# Access Compliance Report

Intersection ID: 52582	Main Street: NOBLES_AV	Cross Street: N/A	Location: NW
ADA ID: A70D8F4599EA	Ramp Type: MedianPerp	Initial Pass/Fail: Fail	Overall Compliance: No
Severity Score: 1.25			
Codes/Mitigation Info/Possible Solution		Field Measurements/Component Compliance

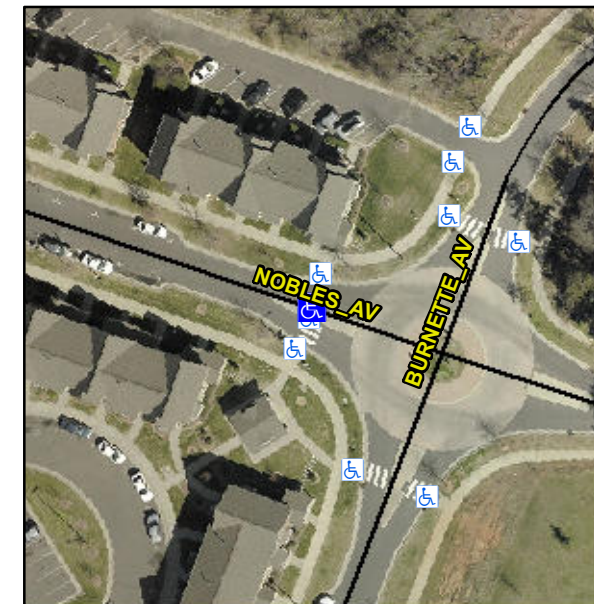
**Not Found, R304.5.3**

Compliance	Description	Data	Compliance	Description	Data
N/A	Ramp Length (in)	24.0	Yes	Ramp Slope (%)	6.1
Yes	Ramp Width (in)	72.0	No	Ramp XSlope (%)	2.8
N/A	Flare Type LT	N/A	N/A	Flare Type RT	N/A
N/A	Flare Slope LT (%)	N/A	N/A	Flare Slope RT (%)	N/A
N/A	Flare Traversable LT?	N/A	N/A	Flare Traversable RT?	N/A
N/A	Landing Length (in)	N/A	N/A	DWS Provided?	N/A
N/A	Landing Width (in)	N/A	N/A	DWS Contrast?	N/A
N/A	Landing Slope (%)	N/A	N/A	DWS Length (in)	N/A
N/A	Landing X Slope (%)	N/A	N/A	DWS Full Width?	N/A
N/A	Landing Curb? (Y/N)	N/A	N/A	DWS Offset (in)	N/A
N/A	Shared Landing?	N/A			
N/A	Gutter Ponding?	N/A	N/A	Gutter Slope (%)	N/A
N/A	Gutter Lip Ht (in)	N/A	N/A	Gutter X Slope (%)	N/A
N/A	Painted X Walk1?	No	N/A	Painted X Walk2?	N/A
	X Walk 1 Direction	To N		X Walk 2 Direction	N/A
N/A	X Walk 1 Width (in)	N/A	N/A	X Walk 2 Width (in)	N/A
	X Walk 1 Slope (%)	1.5		X Walk 2 Slope (%)	N/A
	X Walk 1 X Slope (%)	3.8		X Walk 2 X Slope (%)	N/A

**Remove & Replace Entire Ramp.**
